Proposal #03: 1016-05-75, WISC 2019 066
Tomah – Wisconsin Dells
43rd St W to Seven Mile Creek
IH-90
Juneau County

1016-08-79, WISC 2019 067
Mauston – Wisconsin Dells
24th Avenue to CTH HH (EB Rdwy)
IH-90
Juneau County

This is Addendum No. 01, which provides for the following:

ADDENDUM NO. 01
1016-05-75, 1016-08-79
December 17, 2018

Addendum No. 01
 ID 1016-05-75
 ID 1016-08-79
 Revised Sheet 7
 December 17, 2018

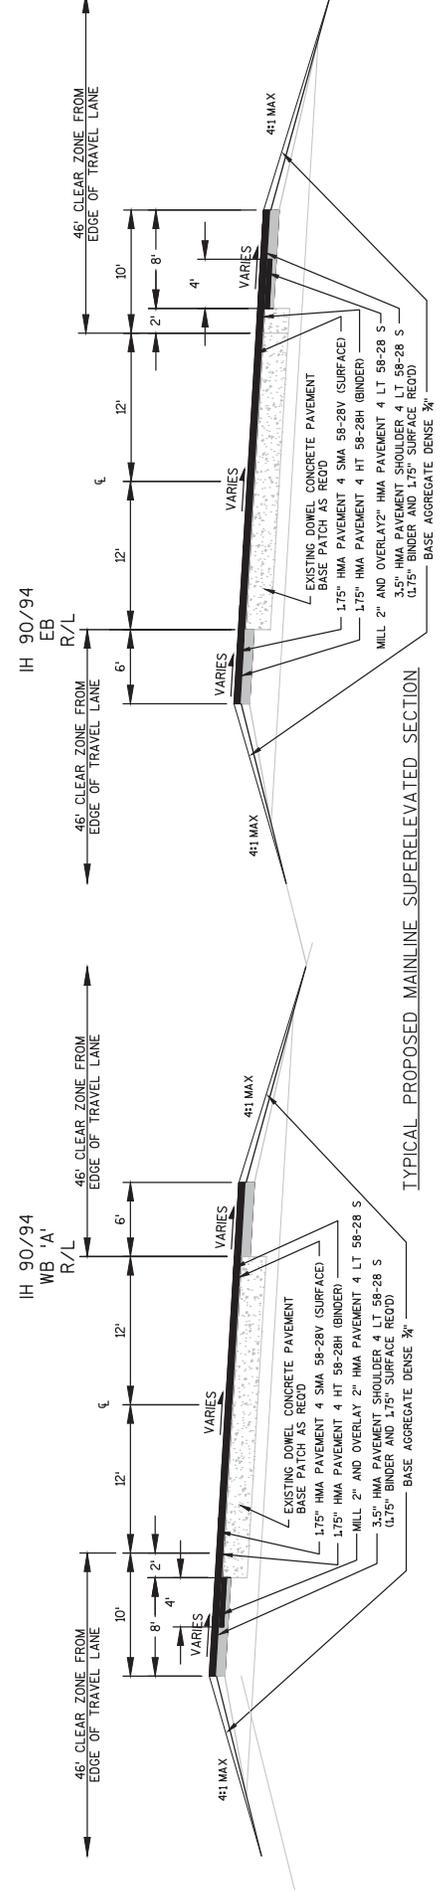
Revised Plan Sheets	
Plan Sheet	Plan Sheet Title (brief description of changes to sheet)
7	Corrected pavement type from 4 LT 58-24 S to 4 LT 58-28 S
29	Added table for 460.2007 Incentive Density HMA Pavement Longitudinal Joint, to clarify it applies to the lower layer joint only
